**T  
E  
C  
H  
N  
I  
C  
A  
L  
T  
I  
P  
S**

**– July 1993 –  
#34**

# TECHNICAL TIPS # 34

## JULY 1993

## *HAND CONTROLS*

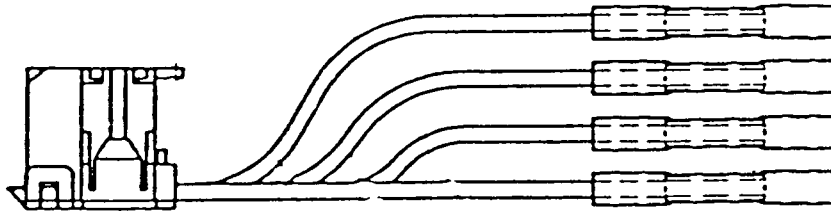
Some dealers have reported that some left side Ultra hand controls are loose after adjusting to customer preference. The fasteners are tight and no gap exists between the clamp halves. The vendor has addressed the situation. This situation can be corrected by filing slightly on the clamp half and touching up with black paint.
